AGENDA
ADA Advisory Committee
Thursday, August 28, 2025
3:00 PM
Evanston Public Library: 1703 Orrington Ave.
First Floor Community Room / Zoom

Memorandum

Subject: Dog Beach ADA Access Discussion

**Evanston Dog Beach ADA Ramp Options
Assessment**

Figure 2-5. Option 1(A).

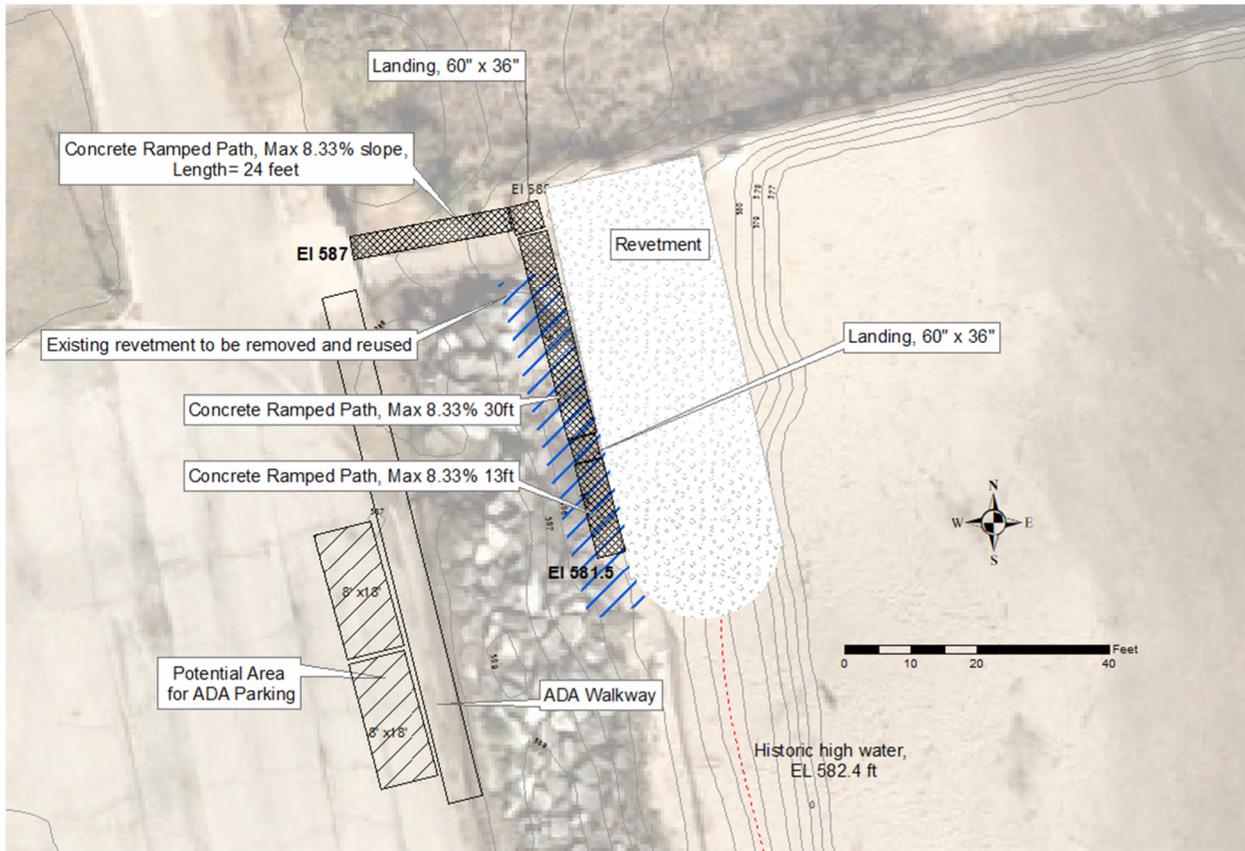
Finding: 3

The landing at the change of direction does not meet minimum size requirements.

Landings at a change of direction shall have a dimension of not less than 60 inches by 60 inches.

2010 ADAS Section 405.7.4

Where ramp runs change direction, an intermediate landing must be provided with a minimum clearance of 60x60 inches measured inside the handrails.

Figure 2-6. Option 1(B).

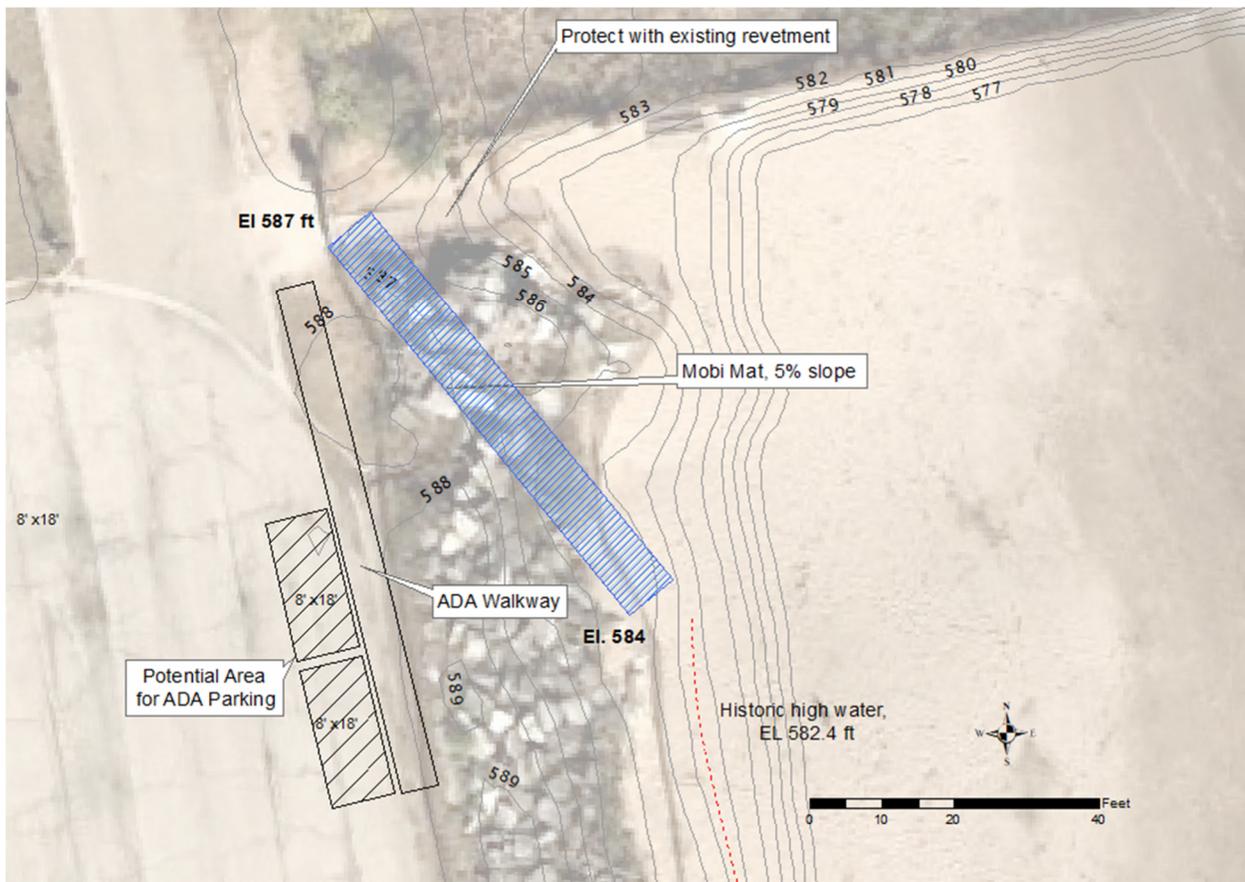
Finding: 5

The minimum clear width for sidewalks and walks is 36 inches.

However, clear width shall be permitted to be reduced to 32 inches minimum for a length of 24 inches maximum provided that reduced width segments are separated by segments that are 48 inches long minimum and 36 inches wide minimum.

**Ensure that the mobility mats
provide a clear width of at least
36 inches throughout.**

Figure 2-7. Option 2.

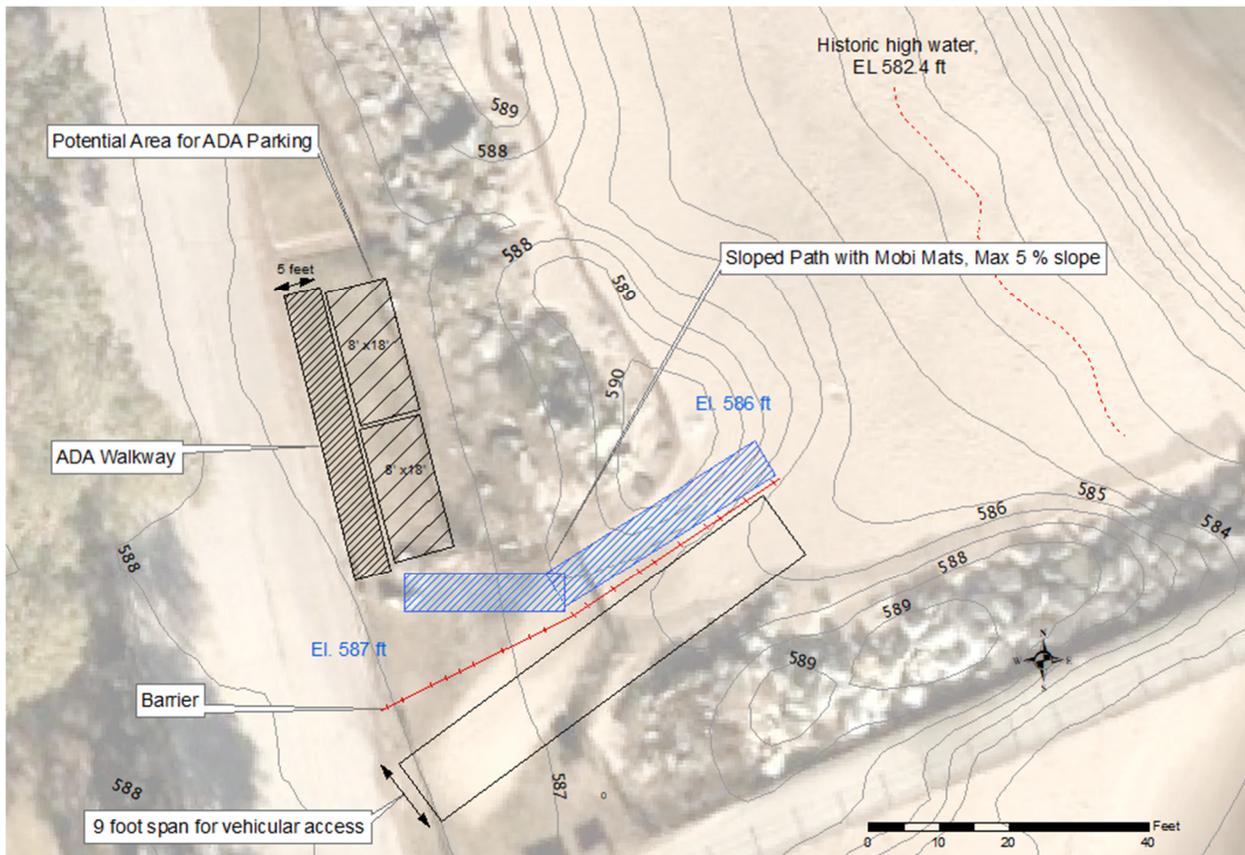
Finding: 6

When the slope in the direction of travel of any walk exceeds 1 unit vertical in 20 units horizontal (5-percent slope), it must be constructed as a ramp. Surface cross slopes must not exceed one unit vertical in 48 units horizontal (2-percent slope).

Finding: 7

The minimum clear width for sidewalks and walks is 36 inches.

The intent of this option is to not require a ramp. Ensure that the running slope is no greater than 5% (1:20).

Ensure that the mobility mats provide a clear width of at least 36 inches throughout.

Figure 2-8. Option 3 from January 13, 2025, Presentation.

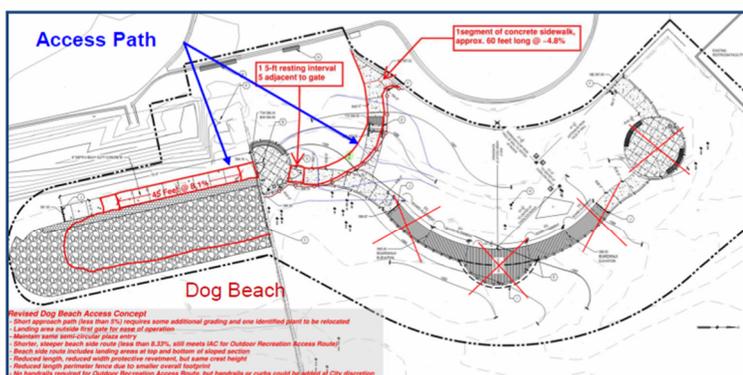
Finding: 8

The maximum rise for any ramp is 30 inches.

Ensure that the ramp runs do not exceed a rise of 30 inches. Intermediate landings must be provided as required to have a vertical change in elevation no greater than 30 inches at each ramp run.
